Accessibility Survey

2nd Street - Brookshire Avenue to End

Brookshire Avenue to End Downey, CA 90242

Date of Inspection 8/9/2017

Change in Level East of End @ 33.939478112388, -118.129439055920

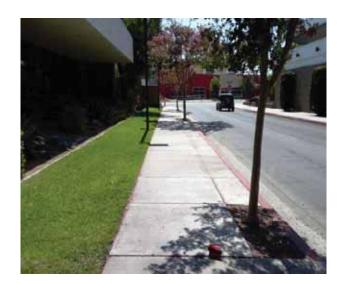
There is a change in elevation greater than recommended value.

On-Site Finding 0.50 inches

Ensure that the change in elevation is within the recommended value.

Change in Level West of Brookshire Avenue @ 33.939627203011, - 118.129854798317

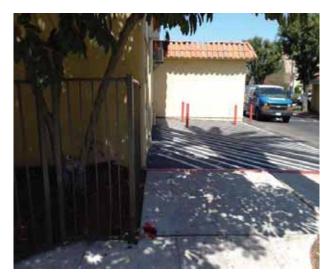
There is a change in elevation greater than recommended value.

On-Site Finding 1.00 inches

Ensure that the change in elevation is within the recommended value.

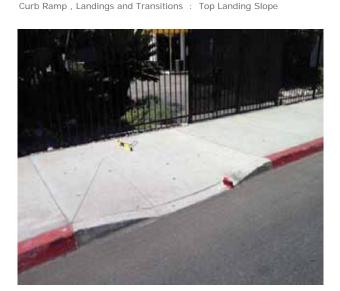
The slope at the top landing is greater than allowed.

On-Site Finding 2.90 percent

Provide a top landing surface that does not exceed the maximum slope and cross slope. Provide a sufficient maneuvering clearance that does not accumulate water.

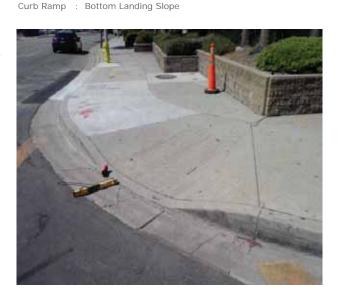
The bottom landing of the curb ramp is on the street, and the slope of the bottom landing is not compliant.

On-Site Finding 12.10 percent

Ensure the bottom landing slope is compliant and provides a smooth transition.

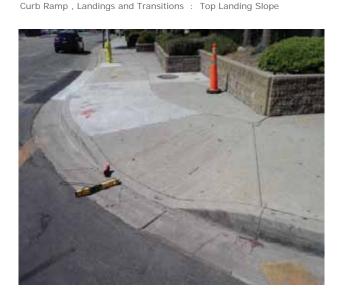
The slope at the top landing is greater than allowed.

On-Site Finding 3.80 percent

Provide a top landing surface that does not exceed the maximum slope and cross slope. Provide a sufficient maneuvering clearance that does not accumulate water.

Change in Level East of Paramount Boulevard @ 33.943008374733, - 118.136062771082

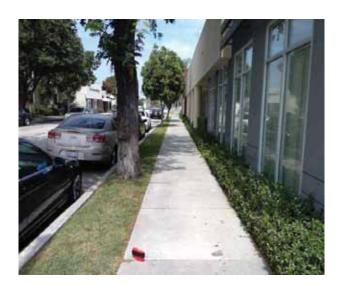
There is a change in elevation greater than recommended value.

On-Site Finding 0.50 inches

Ensure that the change in elevation is within the recommended value.

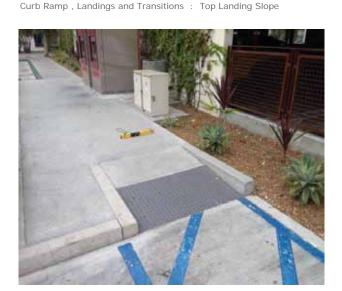
The slope at the top landing is greater than allowed.

On-Site Finding 2.90 percent

Provide a top landing surface that does not exceed the maximum slope and cross slope. Provide a sufficient maneuvering clearance that does not accumulate water.

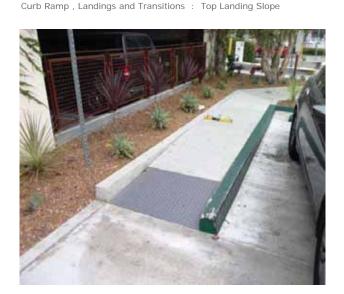
The slope at the top landing is greater than allowed.

On-Site Finding 2.90 percent

Provide a top landing surface that does not exceed the maximum slope and cross slope. Provide a sufficient maneuvering clearance that does not accumulate water.

Change in Level West of Myrtle Street @ 33.942957196432, -118.136269301176

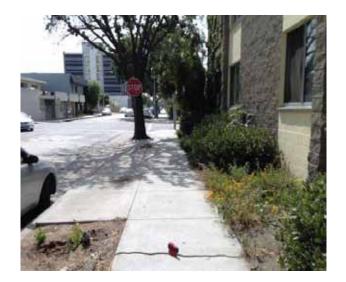
There is a change in elevation greater than recommended value.

On-Site Finding 0.50 inches

Ensure that the change in elevation is within the recommended value.

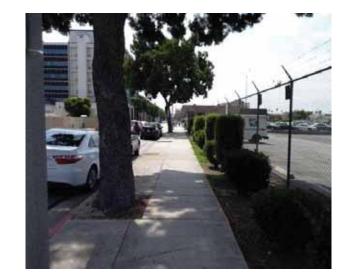
Sidewalk running slope is not compliant.

On-Site Finding 7.50 percent for 4.00 feet

Repave the sidewalk surface with the recommended running slope.

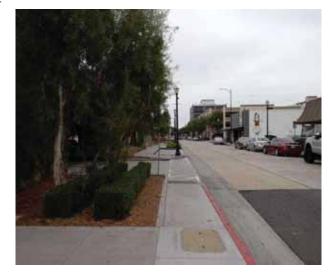
There is no 60X60 turn area at every 200 feet.

On-Site Finding Not Found

Provide a 60X60 turn every 200 feet on the sidewalk.

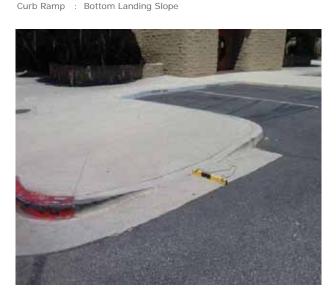
The bottom landing of the curb ramp is on the street, and the slope of the bottom landing is not compliant.

On-Site Finding 6.40 percent

Ensure the bottom landing slope is compliant and provides a smooth transition.

Change in Level East of Rives Avenue @ 33.945440421137, -118.140751272440

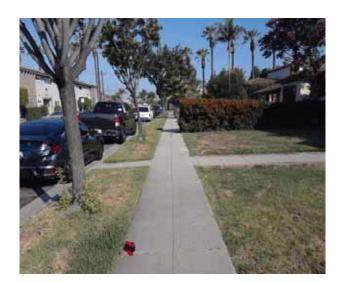
There is a change in elevation greater than recommended value.

On-Site Finding 0.50 inches

Ensure that the change in elevation is within the recommended value.

Change in Level East of Smallwood Avenue @ 33.944656077074, -118.139221072197

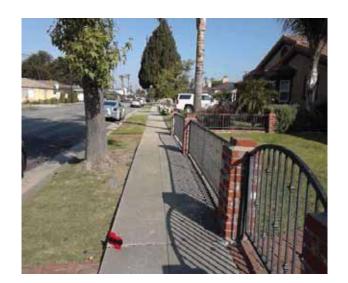
There is a change in elevation greater than recommended value.

On-Site Finding 1.12 inches

Ensure that the change in elevation is within the recommended value.

Change in Level East of Smallwood Avenue @ 33.944695016312, -118.139296174049

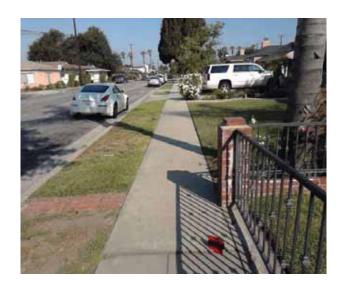
There is a change in elevation greater than recommended value.

On-Site Finding 0.75 inches

Ensure that the change in elevation is within the recommended value.

Change in Level West of Paramount Boulevard @ 33.943921790977, - 118.138130754232

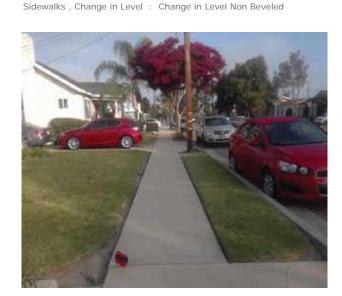
There is a change in elevation greater than recommended value.

On-Site Finding 0.50 inches

Ensure that the change in elevation is within the recommended value.

Change in Level West of Paramount Boulevard @ 33.943988544520, - 118.138266205788

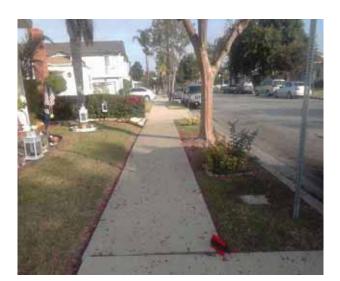
There is a change in elevation greater than recommended value.

On-Site Finding 0.87 inches

Ensure that the change in elevation is within the recommended value.

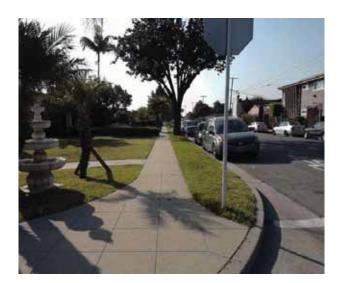
Sidewalk cross slope is not compliant.

On-Site Finding 3.90 percent for 60.00 feet

Repave the sidewalk surface with the recommended cross slope.

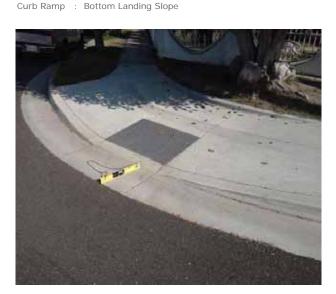
The bottom landing of the curb ramp is on the street, and the slope of the bottom landing is not compliant.

On-Site Finding 6.00 percent

Ensure the bottom landing slope is compliant and provides a smooth transition.
